PROJECT 1801 FRONTAGE ROAD LIVING GREEN TRAIL PROJECT

ADDENDUM NO. 3

Frontage Road Trail Pre-Bid Q & A- 10-24-2023

THE ELEVATION REFERENCE FOR THIS SURVEY IS A CONTRA COSTA COUNTY BENCHMARK, BM ID 171, SET ON AN EBMUD BOX ON THE EAST SIDE OF RAILROAD AVENUE AT THE INTERSECTION OF RAILROAD AVENUE AND ALVARDO STREET.

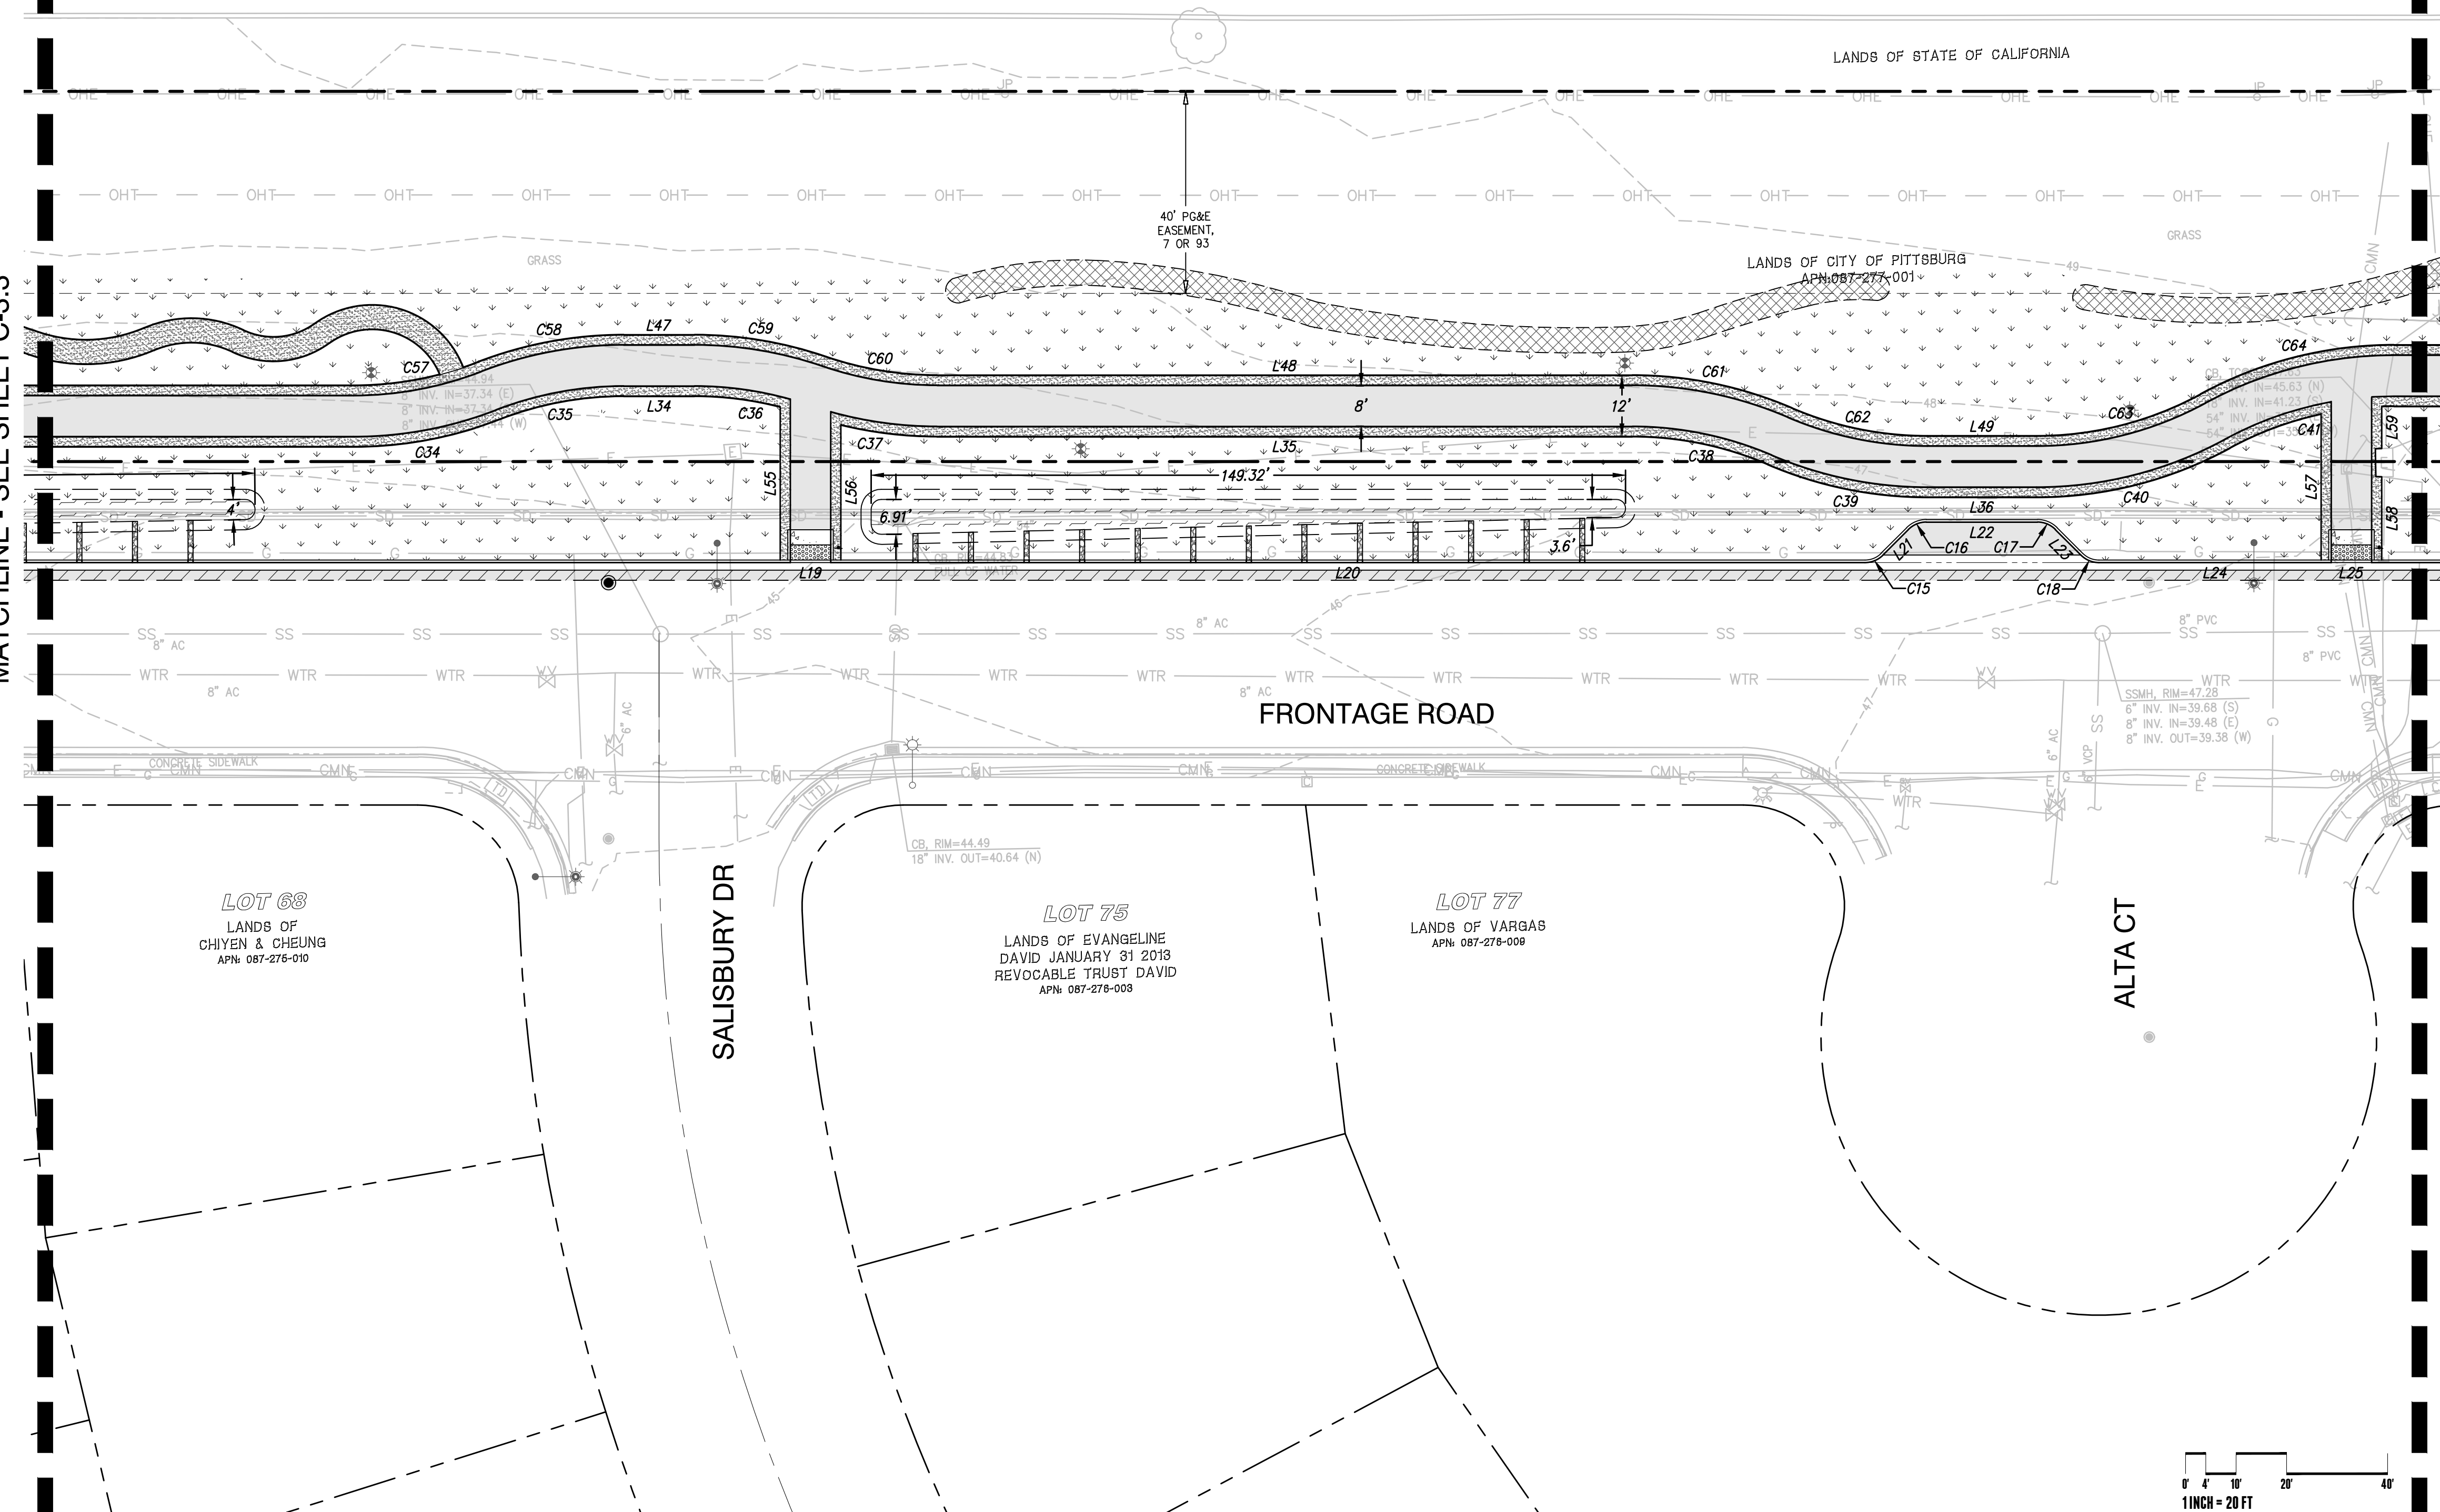
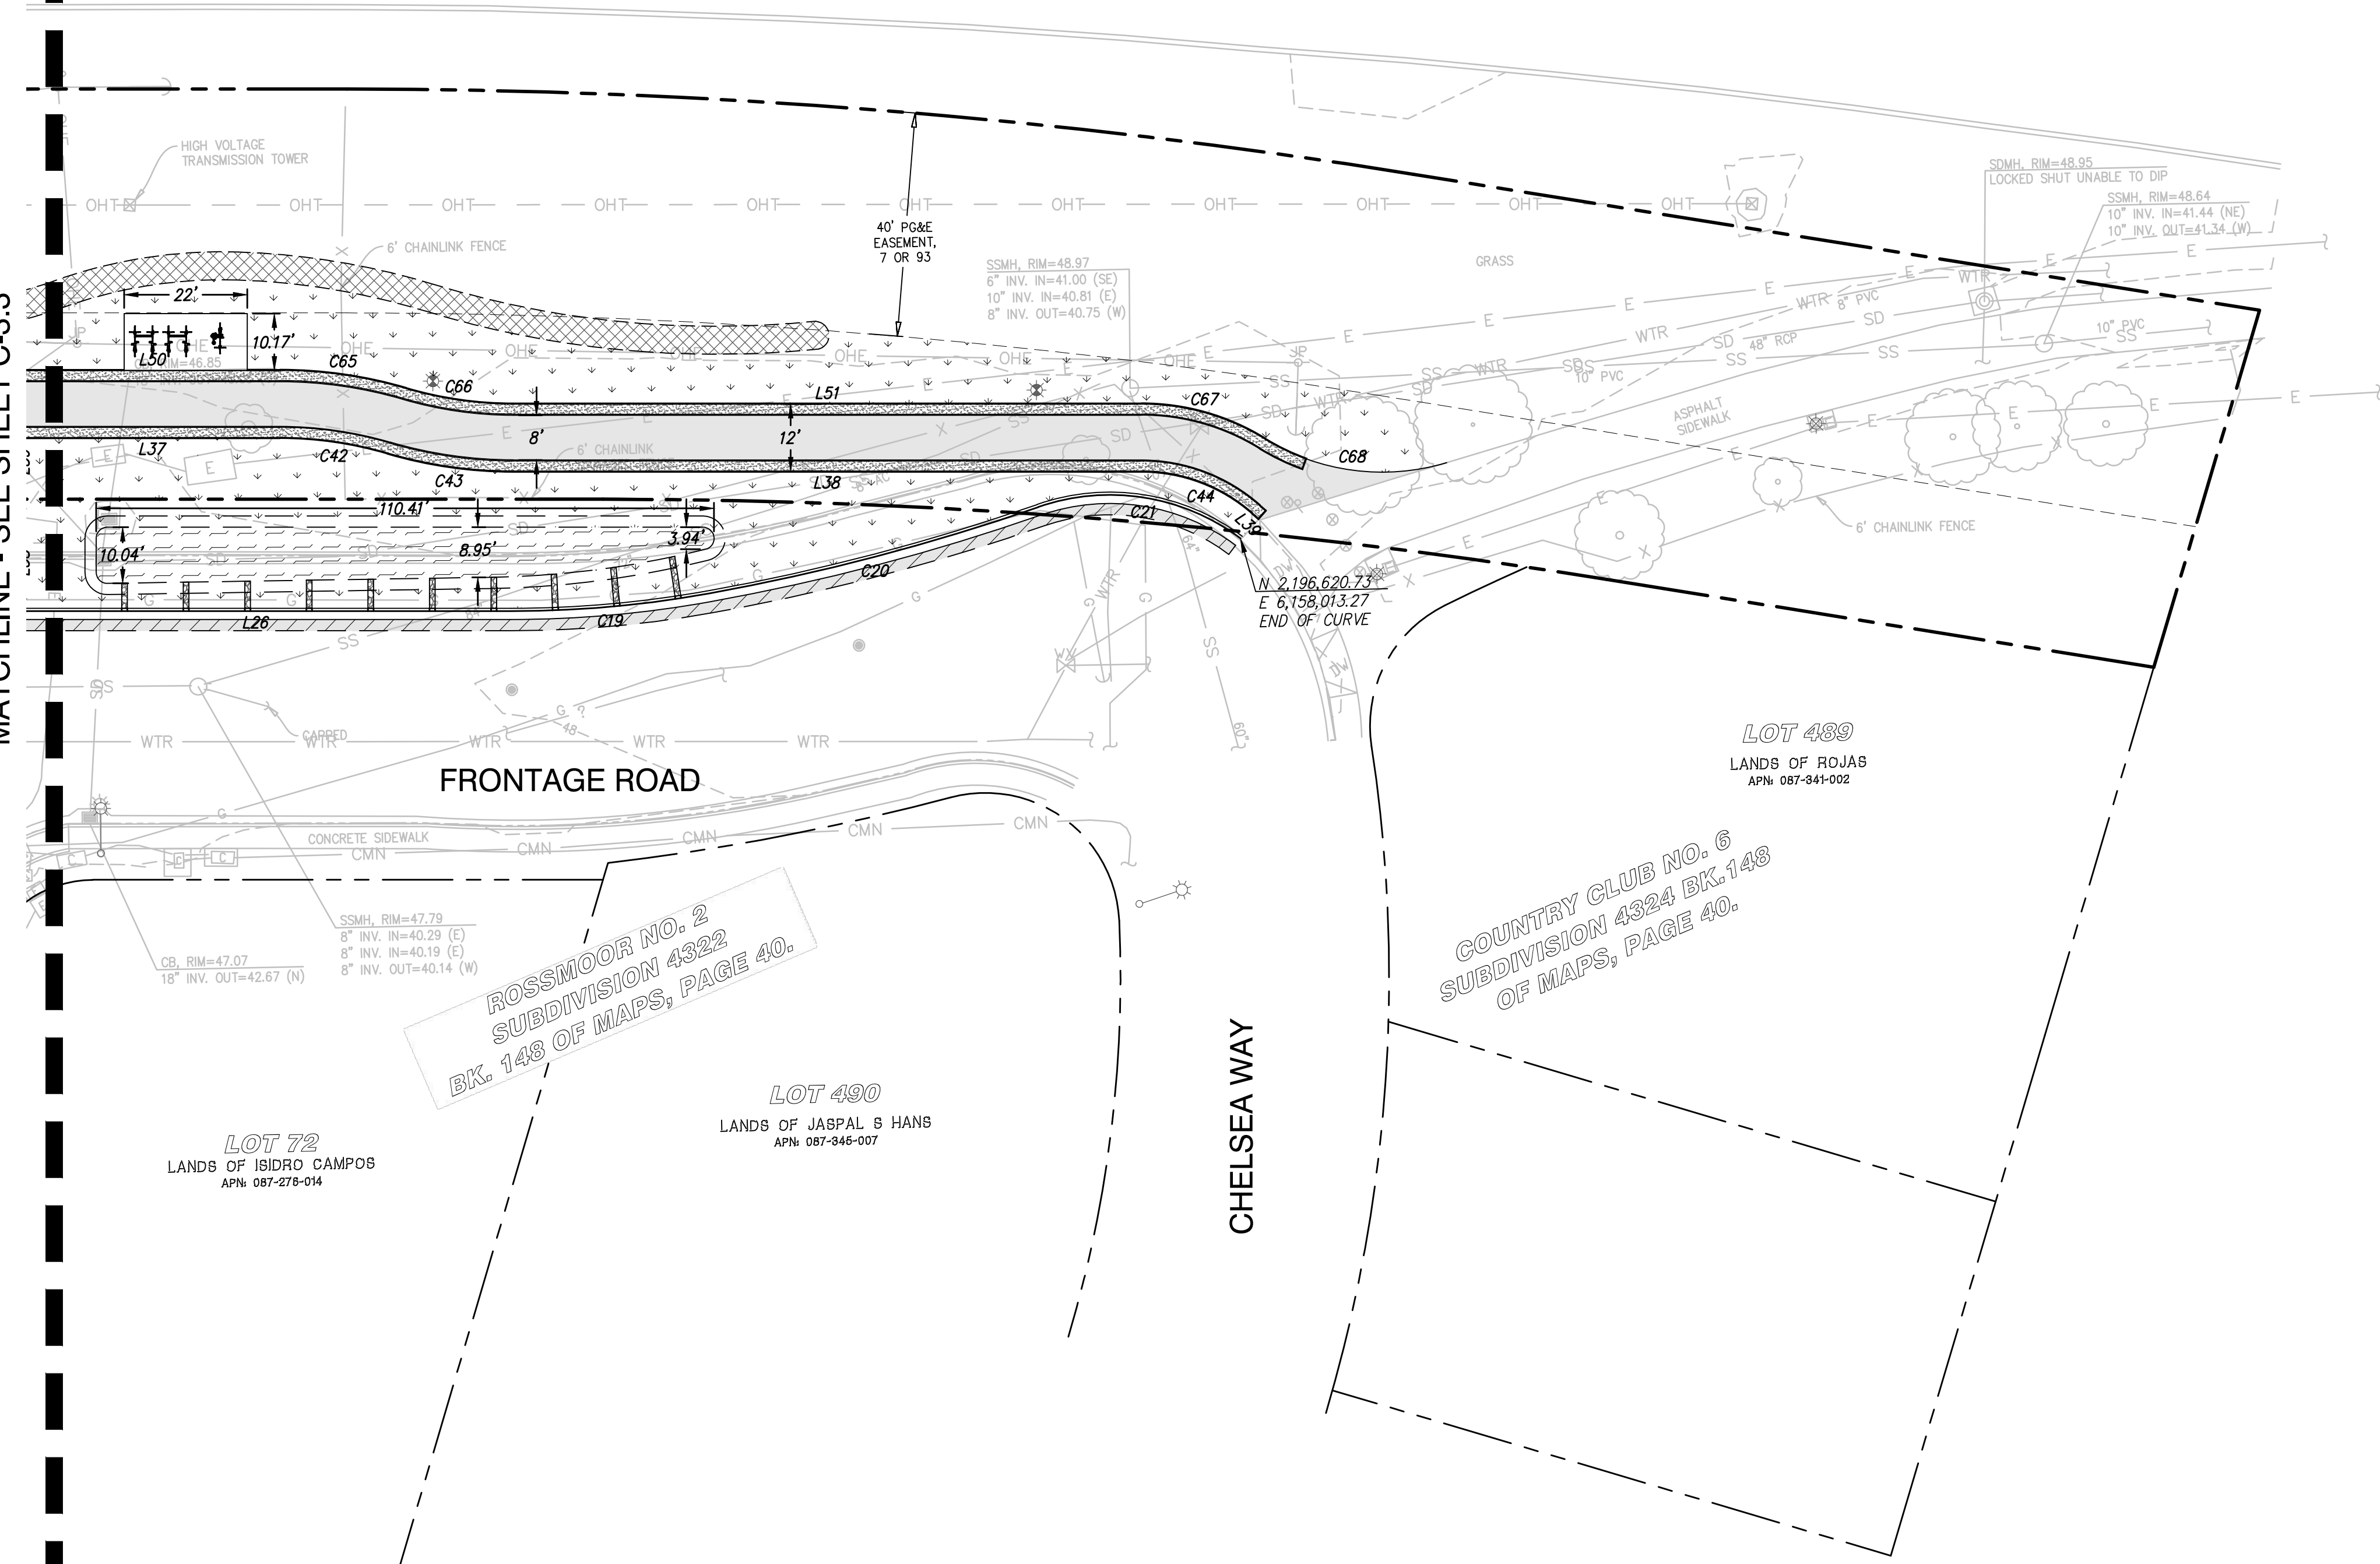
- a. Please be advised of the following clarifications to the contract documents:
 - i. **Concrete Pedestrian Sidewalk Pavement shall be removed and replaced with Asphalt Concrete Pavement with 2 foot decomposed granite shoulders as reflected on the main trail segment. See attached Horizontal Control Plan.**

16. Q: Please clarify horizontal control and layout (line/curve tables, station and offsets) for the project.

A: Refer to the attached horizontal control plan sheets C-3.1 – C-3.4.
